**Addendum No. 2**  
**Rock River Water Reclamation District**  
**Substation 3-6 Electrical Upgrades**  
**Capital Project No. 2023**

This Addendum Number 2, dated June 13, 2019, for the above referenced project, supersedes all contrary and conflicting information in the specifications and contract documents, which are hereby supplemented or revised as follows:

## SUBSTATION 3-6 ELECTRICAL UPGRADES

# EXISTING SITE PIPING PROFILE

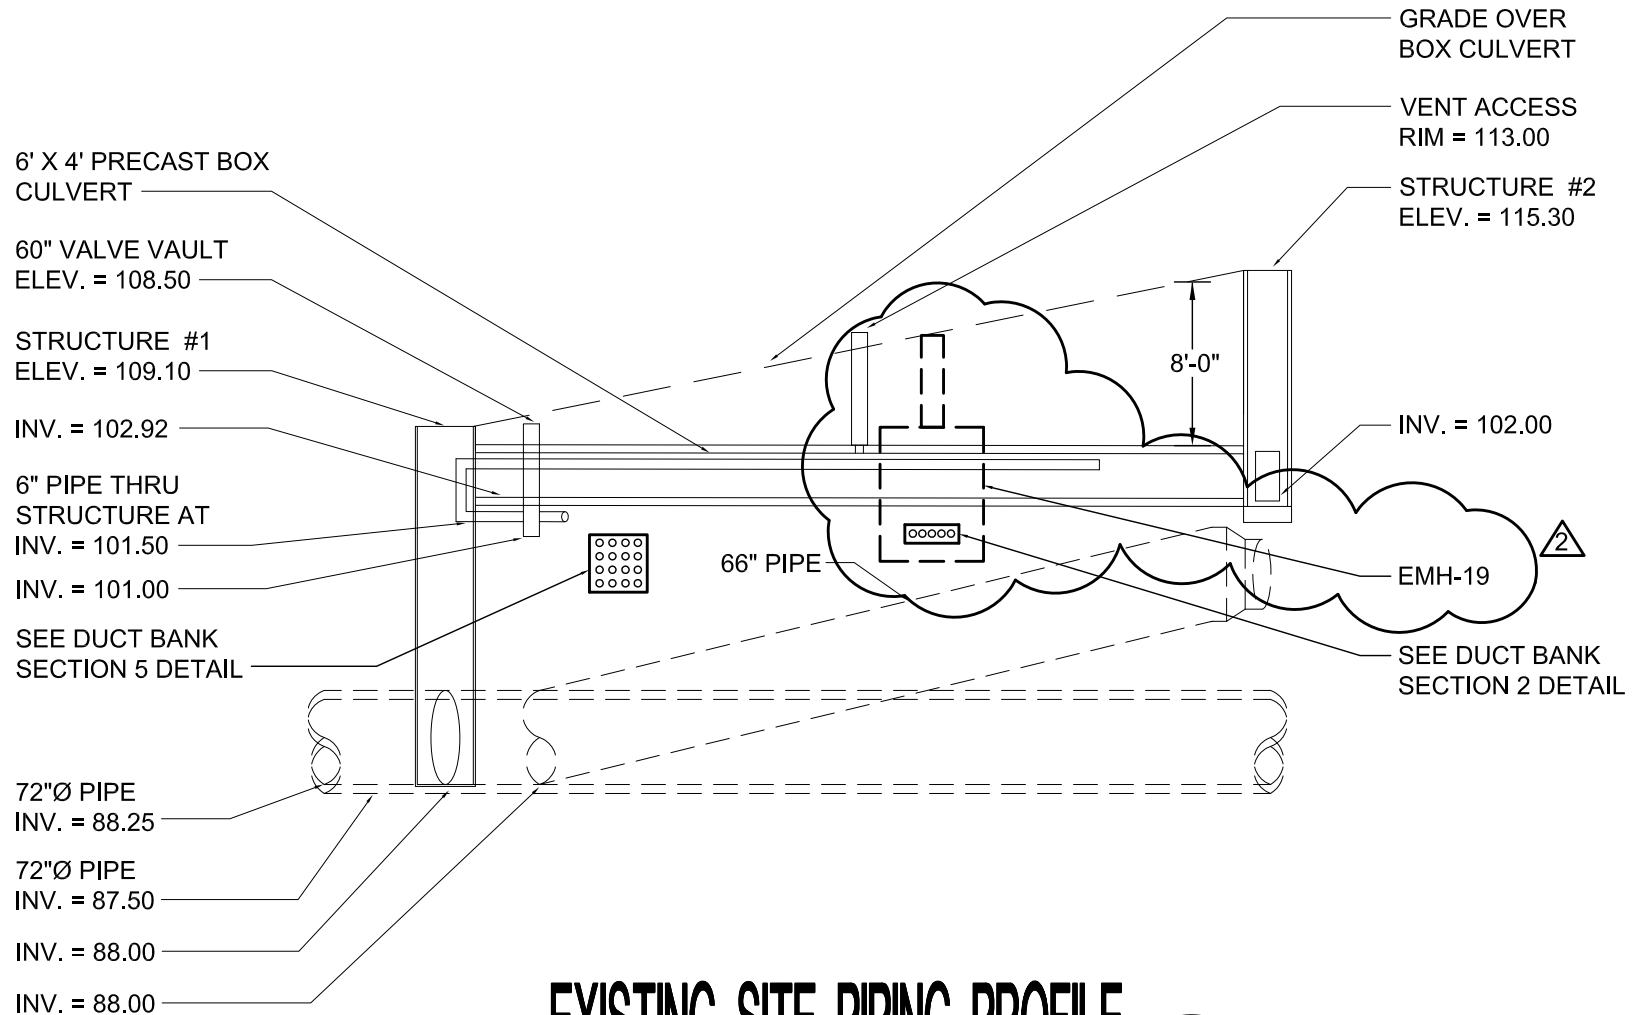
REPLACE Existing Site Piping Profile detail. See attached ADE2.1
